CITY OF WEST LAKE HILLS, TEXAS
NOTICE OF ZONING & PLANNING COMMISSION (ZAPCO) REGULAR MEETING
Wednesday, August 21, 2024 at 6:30 PM

4. Public Hearing 1501 Wildcat Hollow: Discuss and make recommendations on the proposed variances:

5. **Public Hearing 22 Hull Circle:** Discuss and make recommendation on a variance for an 8-foot encroachment into the 20 foot-side setback for the replacement of a non-conforming deck (Section 22.03.276 and 22.03.281 of the West Lake Hills Code).

6. **Public Hearing 102 W Spring Dr.:** Discuss and make recommendations on the proposed variances:
 1. To encroach 16’4” feet into the required 20-foot west side setback (Section 22.03.275 and 22.03.281);
 2. Encroach 8’4” feet into the required 20-foot east side setback (Sections 22.03.275 and 22.03.281); and
 3. Maintain the existing impervious cover allowance of 44.1% (Sections 22.03.278 and 22.03.281 of the West Lake Hills Code).

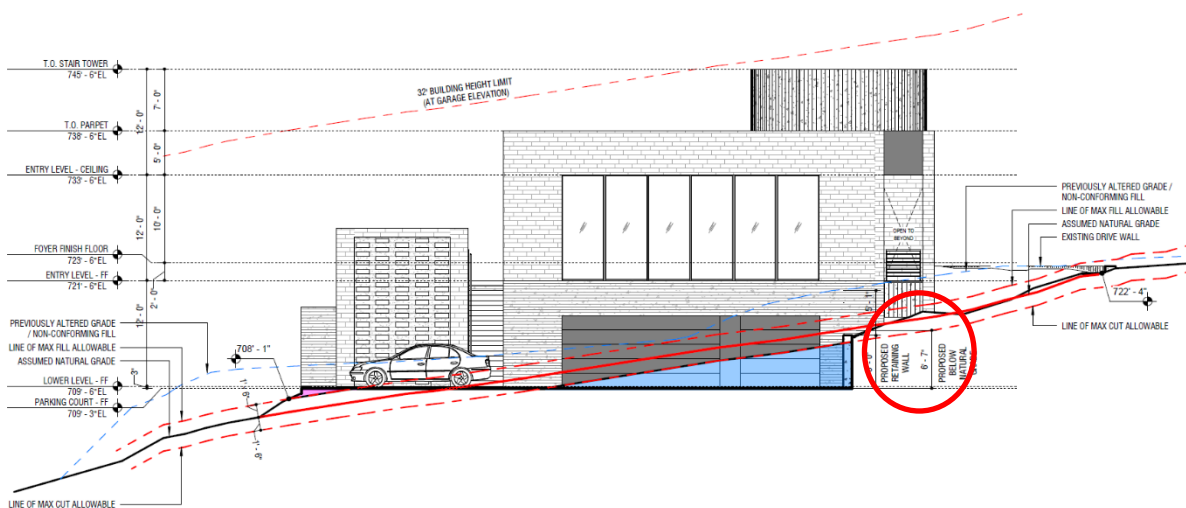
All of the proposed drive court and parking area off Harbor View would be in the 50-foot building setback, in which grading (cut or fill) cannot exceed 18 inches.

On the uphill slope, they are proposing more than 18 inches of cut (up to six feet), and on the down slope, they are proposing more than 18 inches of fill (up to six feet). The proposed area is indicated to have 0% slope. Some of the excess grading could be limited with a partial match of the existing slope. The drive court area size could also be reduced, considering that they are also asking for the existing circle drive that provides additional parking to remain.

2. Allow a retaining wall up to 6'7" in height above natural grade, where the maximum wall height anywhere on the site is 6 feet. (Section 22.03.170);

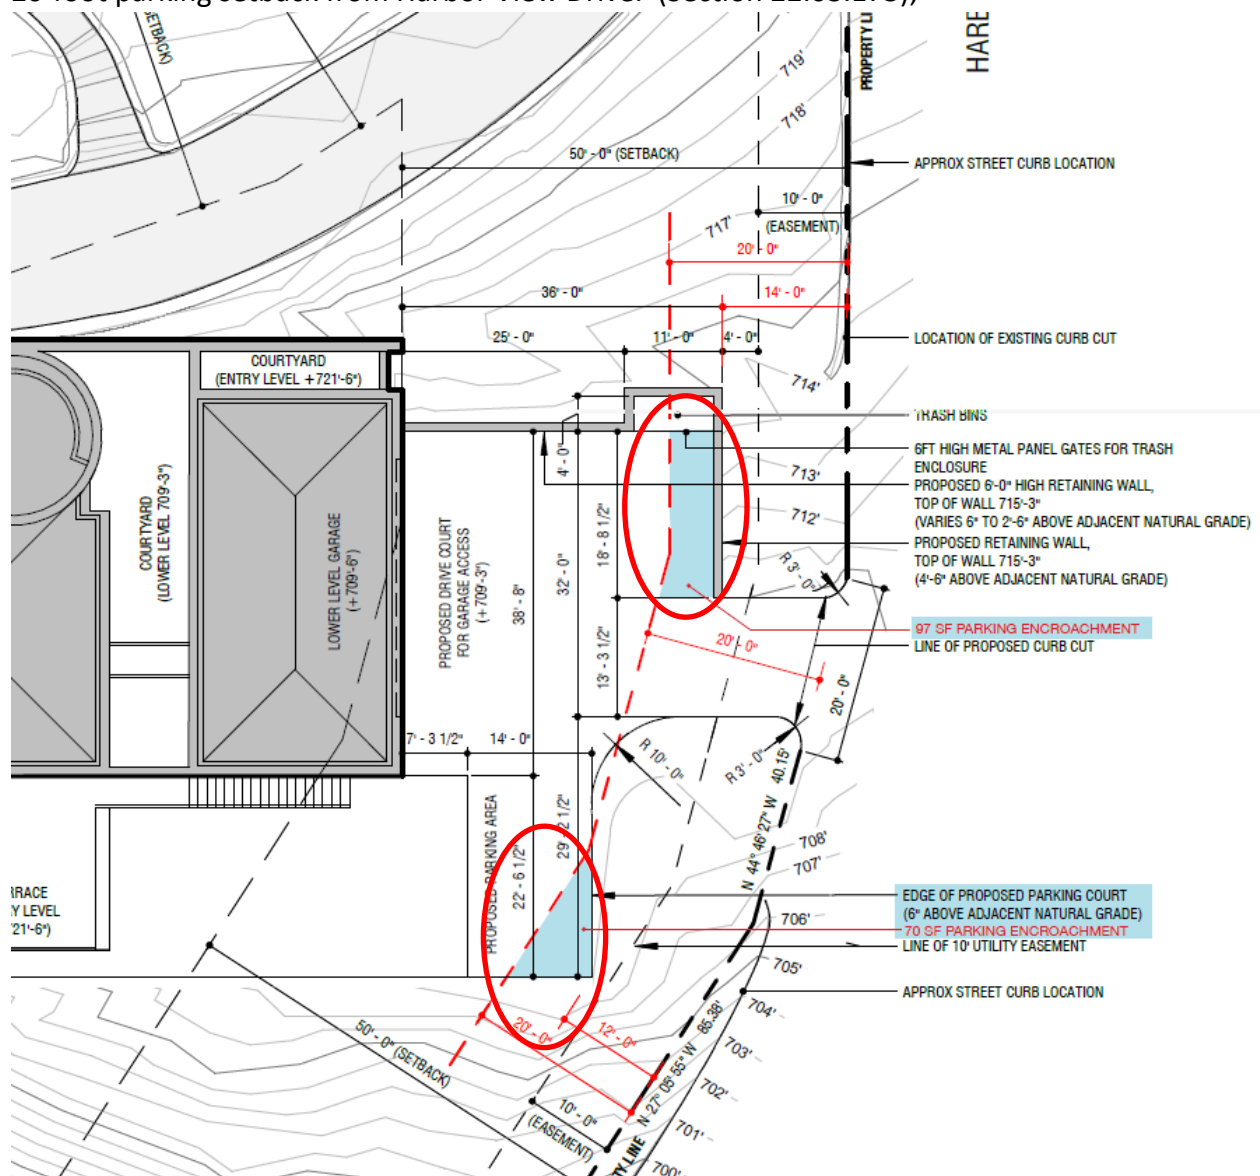
This variance request goes along with the first variance request. Determining the "natural grade" on an already disturbed site is difficult. They have estimated the original grade (solid red line) and that the grade cut from that point is 6 feet 7 inches.

3. Allow an encroachment of 6 feet for a drive court and 8 feet for a side parking area, into the required 20-foot parking setback from Harbor View Drive. (Section 22.03.175);

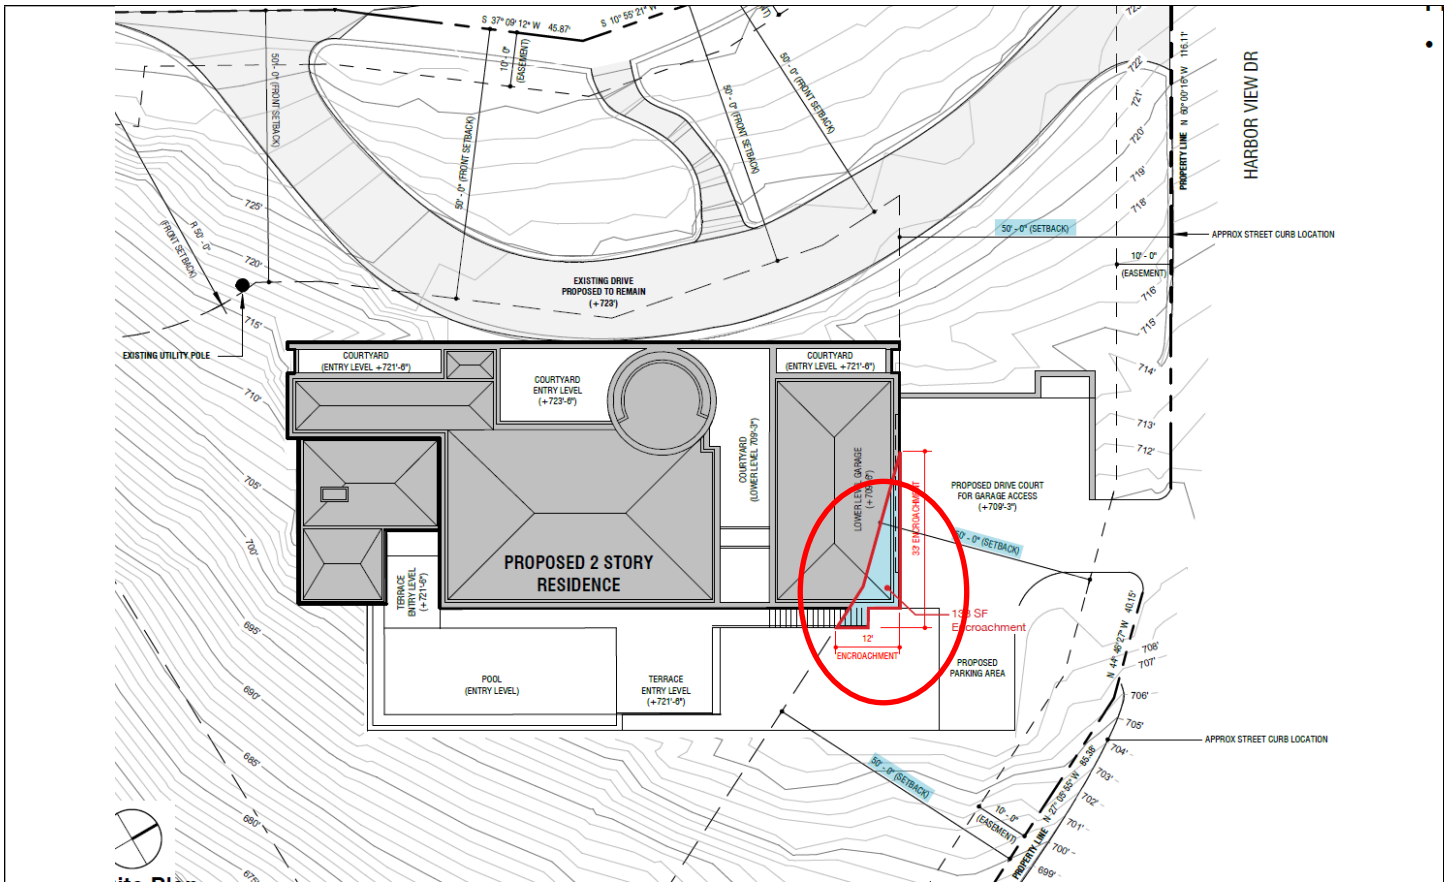
Both of these encroachments seem driven by the proposed location of the house and the size of the drive court.

Proposed design I North elevation along Harbor View

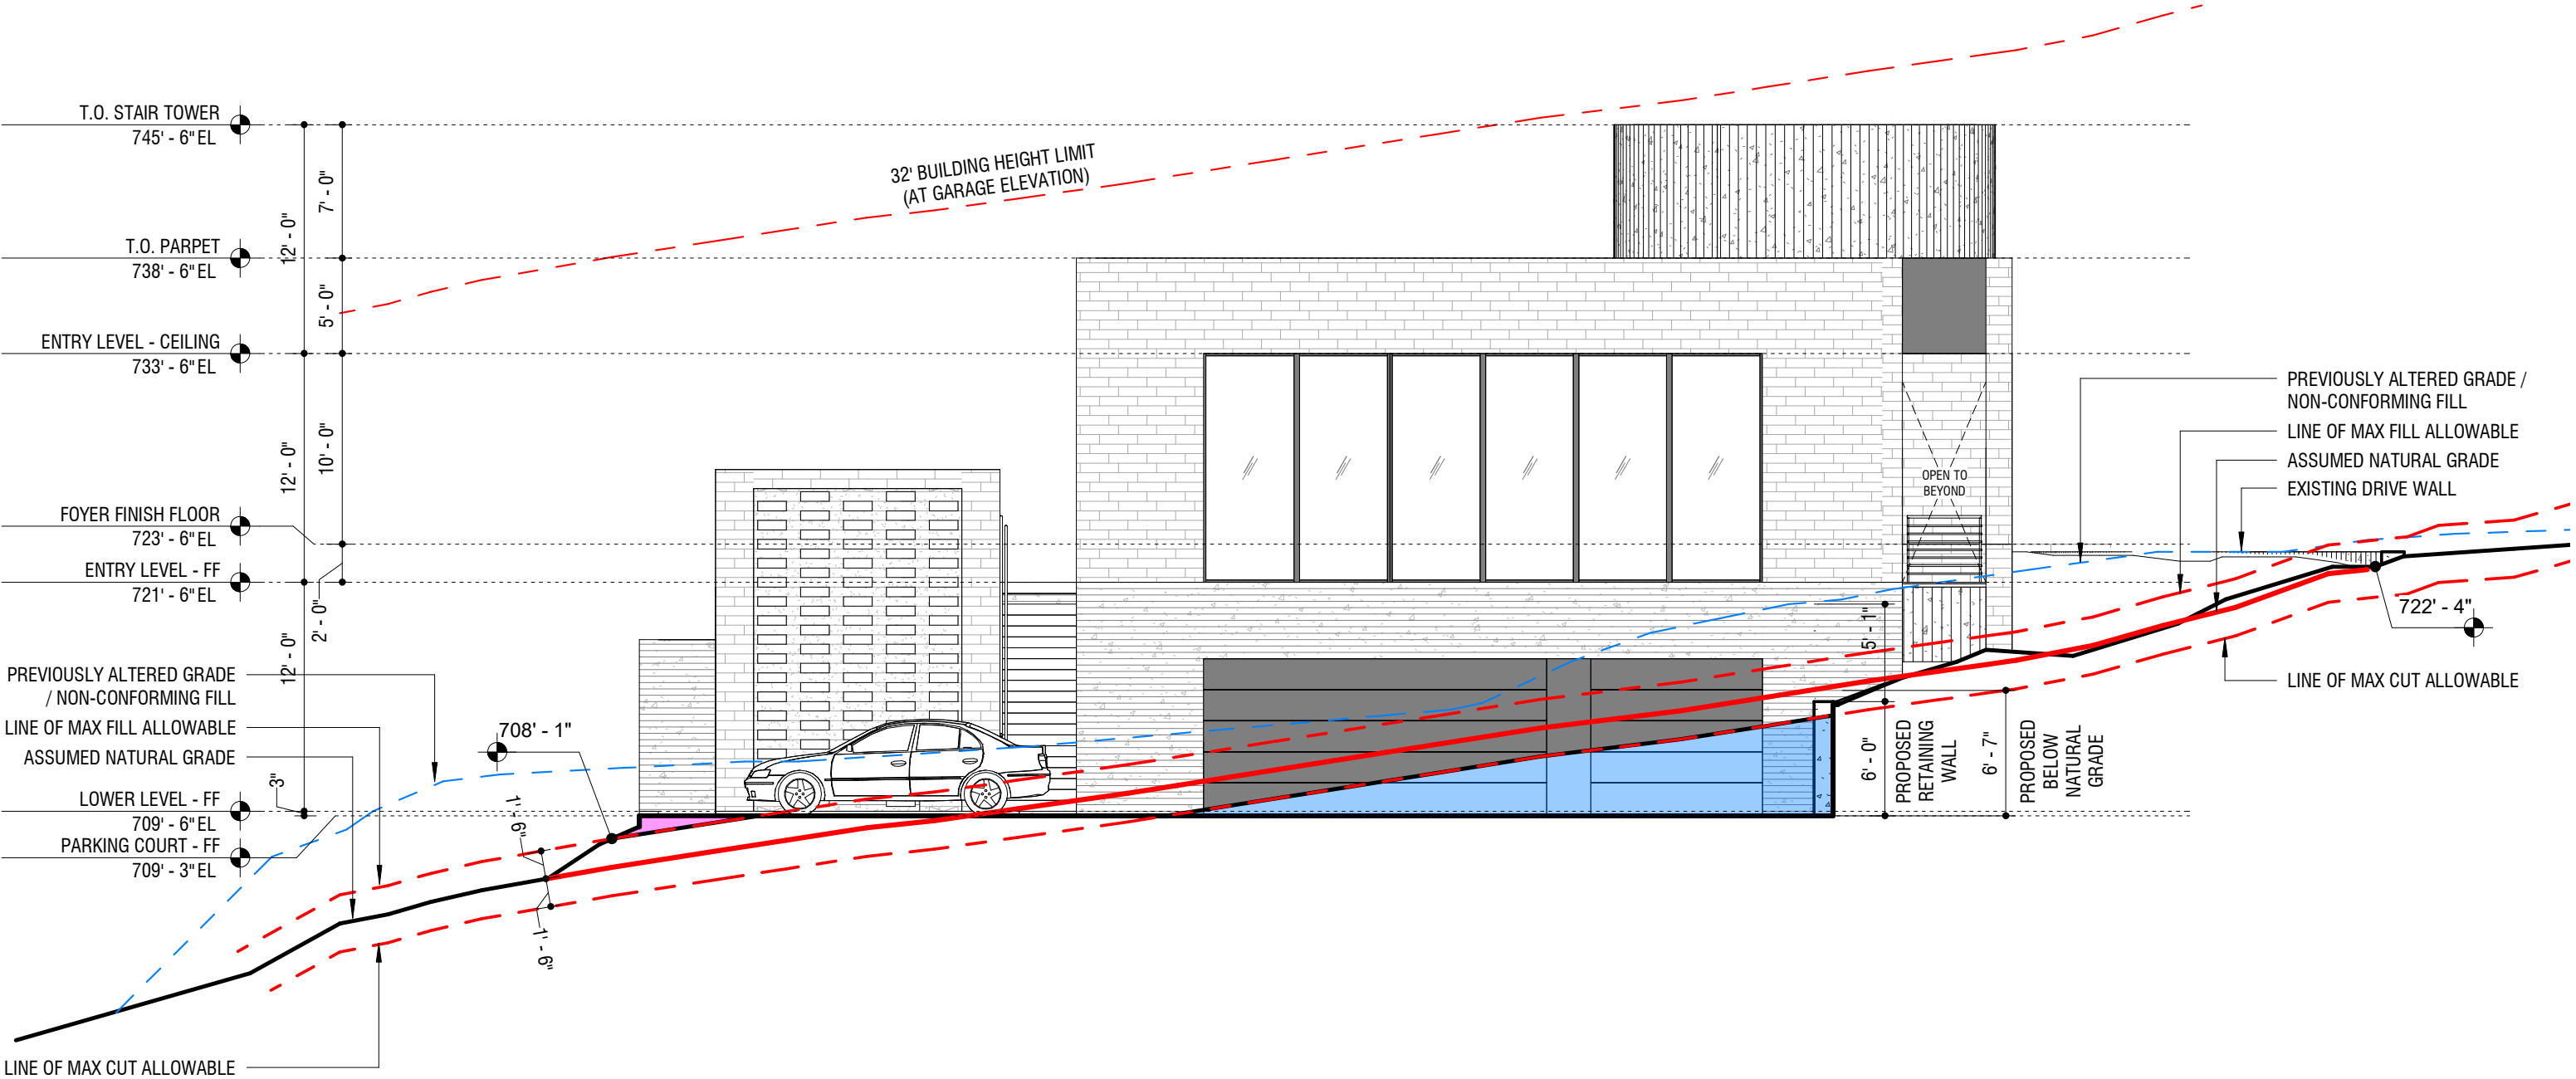
- 2. Allow 6'7" retaining wall from line of assumed natural grade.
 - a. **Assumed natural grade is not an item which is taken into account when reviewing grading plans. Only natural grade, which is the existing grade as documented by a licensed surveyor, should be compared to proposed grade. The engineering team cannot support this request given the proposed wall height exceeds allowable open cut (Ch. 7 Drainage Manual) and the walls are located within the setback where 18" of maximum grade change is allowed per the city code of ordinances.**
